DRB Review

71st Street and Indian Creek Drive

Town Center Gateway

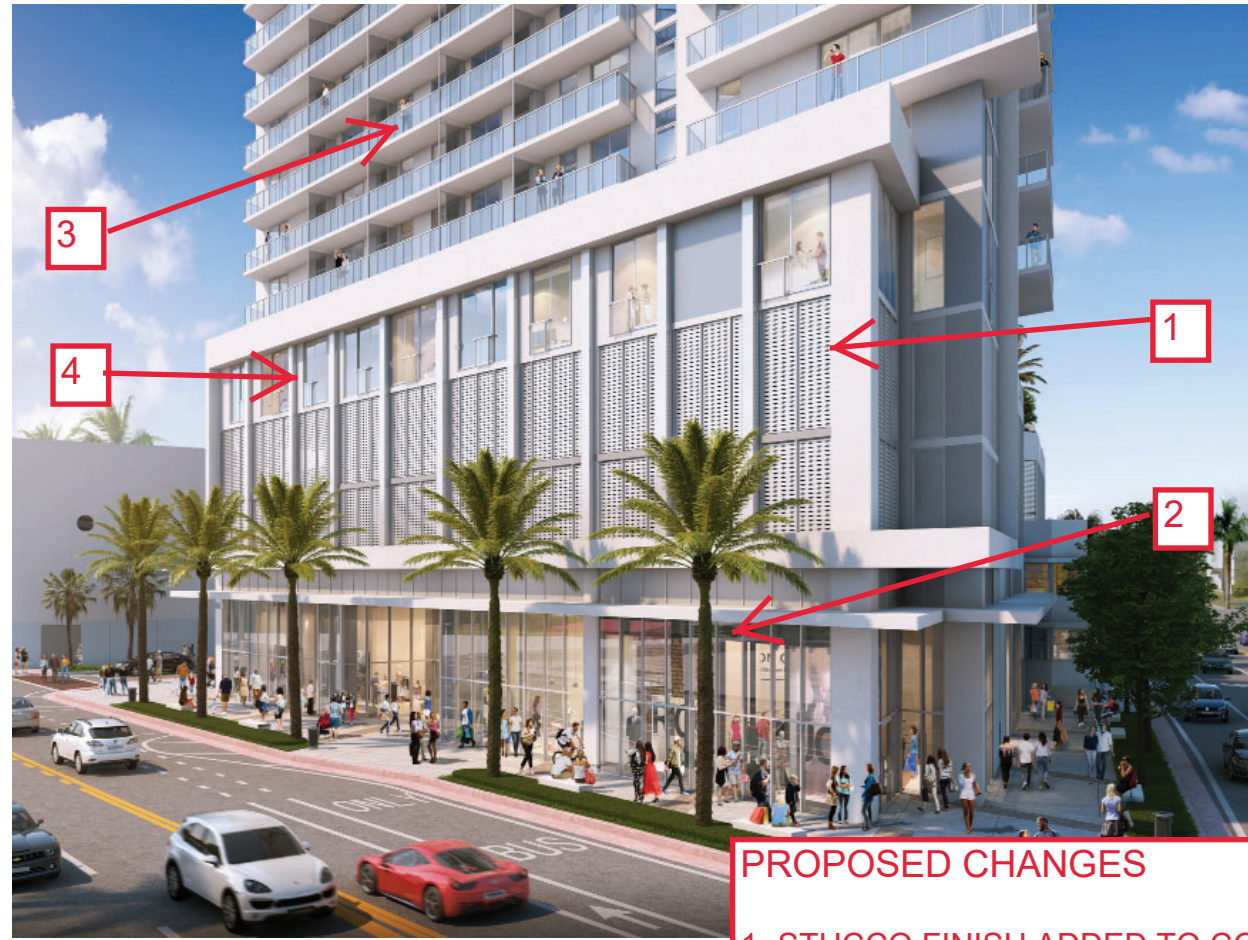
PROPOSED CHANGES

- 1- STUCCO FINISH ADDED TO CORNER COLS
- 2- RAISED SHADE CANOPY UP 2'-0"
- 3- COMBINING NORTH BALCONY RUN
- 4- LOWERED PODIUM 1 FLOOR

BASED ON STAFF INPUT

- 1- ADDED SPANDREL GLASS TO CORNER
- 2- ADDED BREAK IN NORTH BALCONY RUN

Actual Perforation Pattern

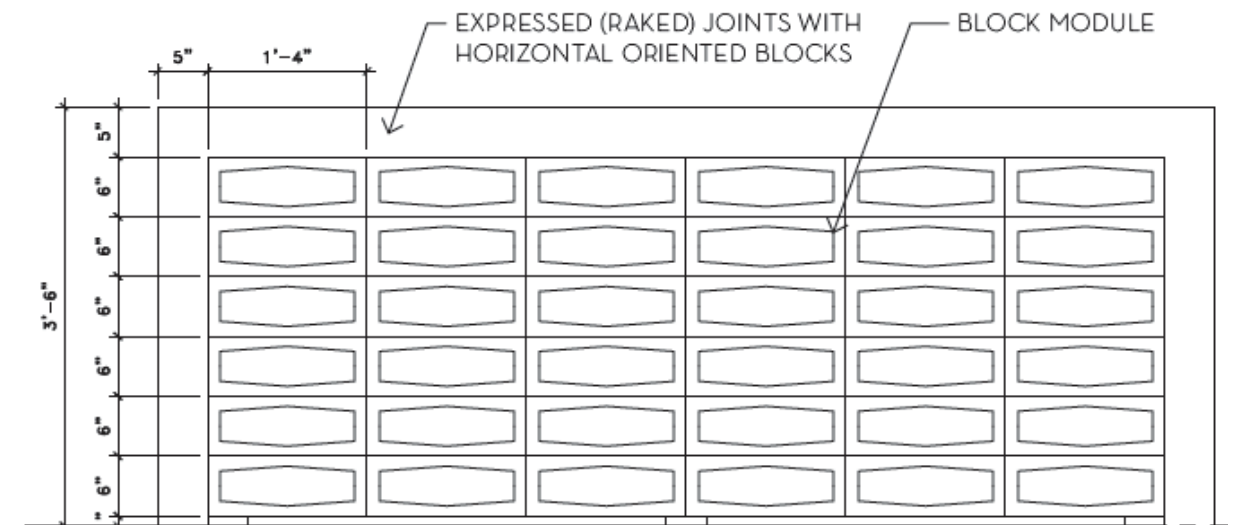
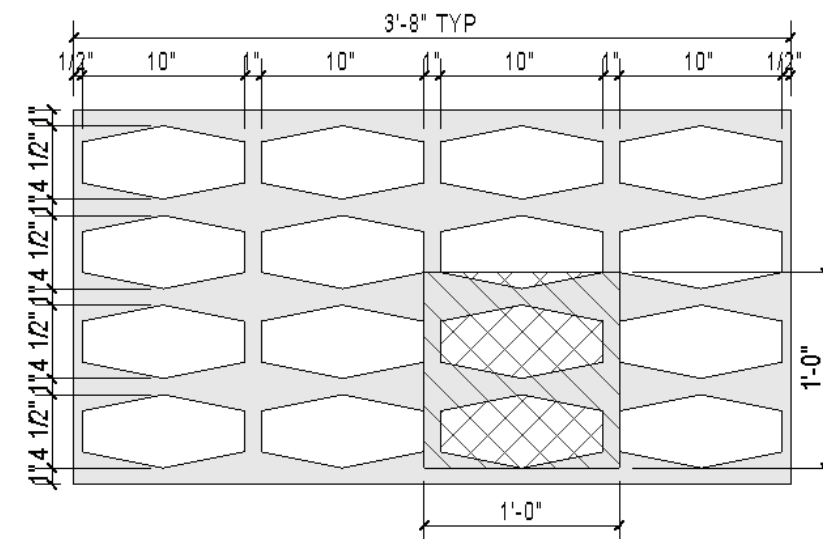
LINEAR OPEN PERFORATION PERCENTAGE:
 $(10" \times 4) / 3'-8" = 90.9\%$

OPEN AREA PERFORATION PERCENTAGE:
 $(0.2431 \text{ SF} \times 2) + 0.0347 \text{ SF} = 0.5209 = 52.09\%$

Precedent Pattern:
Selected from the Post-War Modern / MiMo Design Guideline, the Harlequin pattern of the modular concrete breezeblock is most similar to the original intent and lends itself well to the use in perforated metal panel screening
